Access Compliance Report Public Rights-of-Way (Curb Ramps)

Intersection ID: 28495 Main Street: TYVOLA CENTRE DR Cross Street: CAMERON WALK CT Location: NW **Overall Compliance: No** ADA ID: 1F82BE04FEE3 Ramp Type: Perp Initial Pass/Fail: Fail Severity Score: 13.75

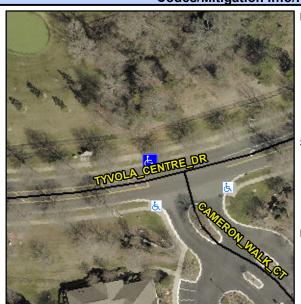
TYVOLA CENTRE DR Street 1 Name Stop Condition-Street 2 None N/A Street 2 Name Stop Condition-Street 1 N/A Possible Solutions: Compliance Description N/A Remove & Replace Entire Ramp. Yes Surveyor Notes: N/A PROW/ADA: R304.2.2, R304.5.3

No Ramp XSlope (%) Ramp Width (in) 55.0 N/A N/A Flare Type LT N/A Flare Type RT N/A Flare Slope LT (%) N/A N/A Flare Slope RT (%) N/A Flare Traversable LT? N/A N/A Flare Traversable RT? N/A Landing Length (in) N/A N/A **DWS Provided?** N/A Landing Width (in) N/A N/A **DWS Contrast?** N/A N/A N/A Landing Slope (%) DWS Length (in) N/A Landing X Slope (%) N/A N/A DWS Full Width? N/A Landing Curb? (Y/N) N/A N/A DWS Offset (in) N/A N/A Shared Landing? **Gutter Ponding?** N/A N/A Gutter Slope (%) Gutter Lip Ht (in) N/A N/A Gutter X Slope (%) Painted X Walk1? No N/A Painted X Walk2? X Walk 1 Direction To S X Walk 2 Direction N/A X Walk 2 Width (in) X Walk 1 Width (in) X Walk 1 Slope (%) X Walk 2 Slope (%) 4.1 X Walk 2 X Slope (%) X Walk 1 X Slope (%) 2.6 N/A N/A Ramp inside XWalk2? Ramp inside XWalk1? Road Slope (%) N/A N/A Clear Space? N/A Road X Slope (%) N/A Clear Space to XWalk (in) N/A Any Obstructions? N/A Storm Grate/Utility Hazard? **Obstruction Type** Storm Grate/Utility Type N/A Surface Condition? (G/P)
